CAMERON PRAIRIE REFUGE PROTECTION (ME-09)

I. INTRODUCTION

VII. PROJECT REVIEW TEAM

Figure 1. Project boundaries and features.

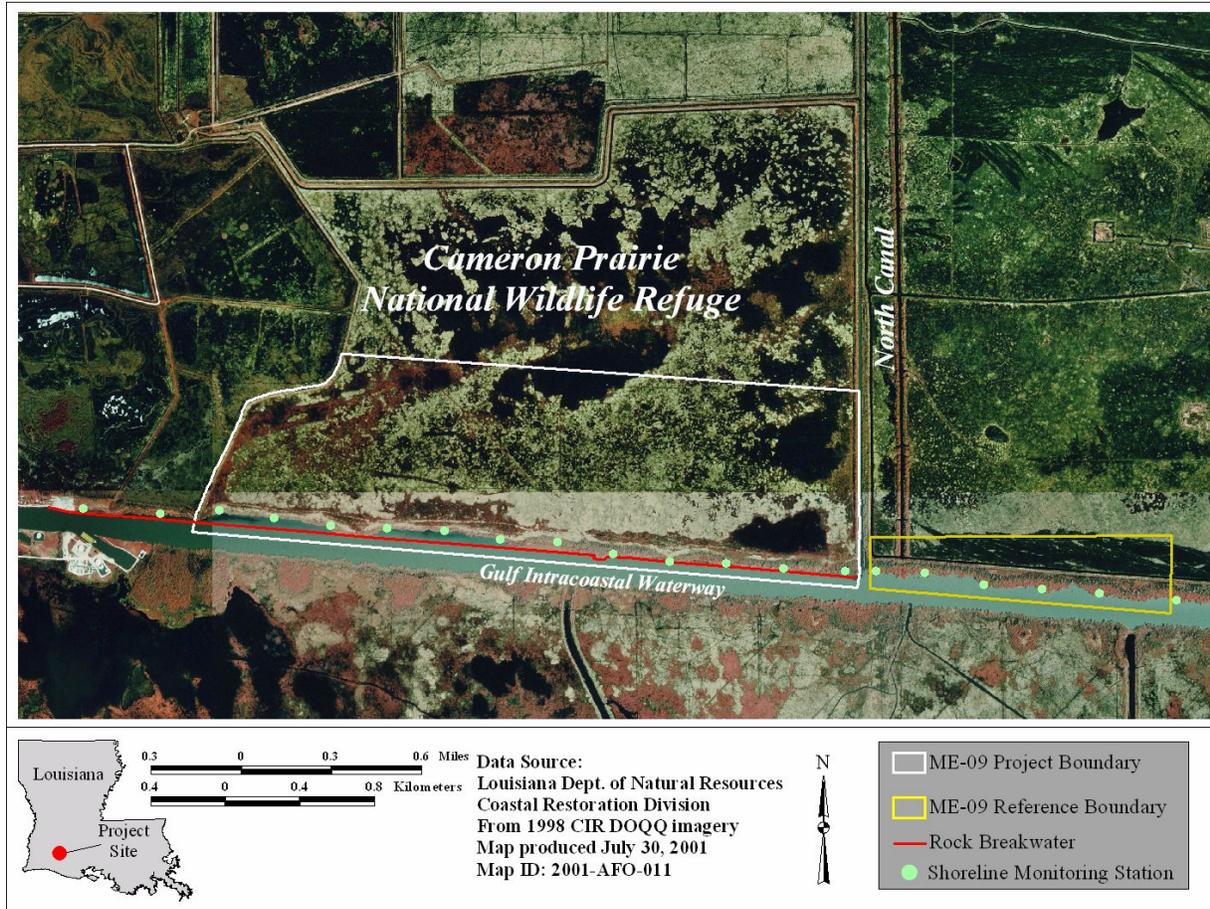
The project description in the CWPPRA Plan (CWPPRA 1993) indicated that the project would armor 6,000 ft (1,829 m) of shoreline but 13,200 ft (4,023 m) of shoreline were armored according to the first Comprehensive Monitoring Report (DNR 1997). The length was increased to tie into pre-existing riprap shoreline protection to the west east but the increase was not essential because other shoreline protection projects have tied into existing shoreline (e.g. see Cote Blanch Hydrologic Restoration). The justification for increasing the length of shoreline protection 220%, and hence the cost, was not indicated. This was already one of the most costly, least beneficial projects on the first priority list (see appendix 1). It is not clear if such an increase in length would be approved if the project were being planned today because the cost increase is unknown and because there is conflicting guidance regarding the need for Federal Sponsors to request Task Force approval to proceed under such circumstances. See sections 5. d. (1) and 6. e. (2) of CWPPRA (2002) for conflicting guidance on project modifications. Despite more than doubling the shoreline protected and increasing the cost, the anticipated wetland loss prevented by the project remained at 247 ac from CWPPRA (1993) through the 2nd Comprehensive Monitoring Report (Barrilleaux and Clark 2002).

The project design consists of installing a rock dike (breakwater) to protect the remaining shoreline. In August 1994, a 13,200 ft (4,023 m) rock breakwater was constructed 0-50 ft (0-15.24 m) from, and parallel to, the northern bank of the GIWW in 3 to 4 ft (0.9 to 1.2 m) of water. The purpose of the breakwater is to prevent the encroachment of the GIWW into the project area by preventing the waves caused by boat traffic from eroding the remaining spoil bank. The project objectives are to prevent the loss of 247 ac (100 ha) of emergent wetlands of the Cameron Prairie NWR adjacent to the GIWW and to prevent the widening of the GIWW into the NWR.
